SRPI.22.061  
Appendix "B"

**MEMO TO:** Kaitlyn Graham, Senior Planner - Development

**File Number(s):** D01-22001  
D02-22001  
D03-22001

**Applicant:** Parioli Peak Estates  
**Location:** 77 & 89 16<sup>th</sup> Avenue

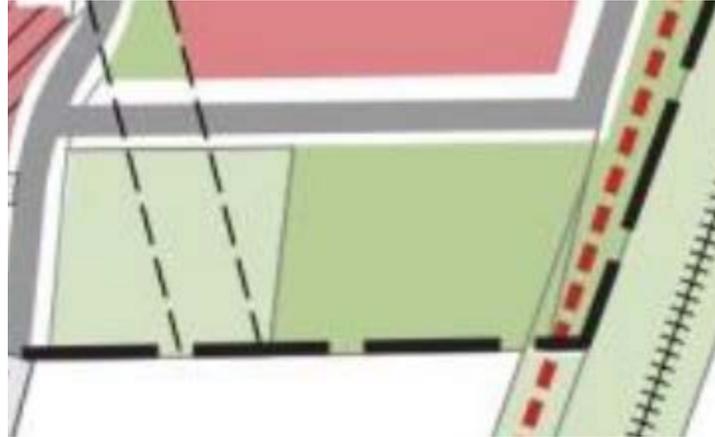
5. The submitted drawings show the "planned public park" extending beyond the subject property boundaries onto adjacent properties (as shown below). The 16th KDA Policy Directions Report does contemplate a "Potential Parks / Open Space / Plaza" and "Potential Trail" in this location, these lands are not part of the subject property or proposed development. As such, the drawings should be revised to ensure that the "planned public park" is contained within the property.
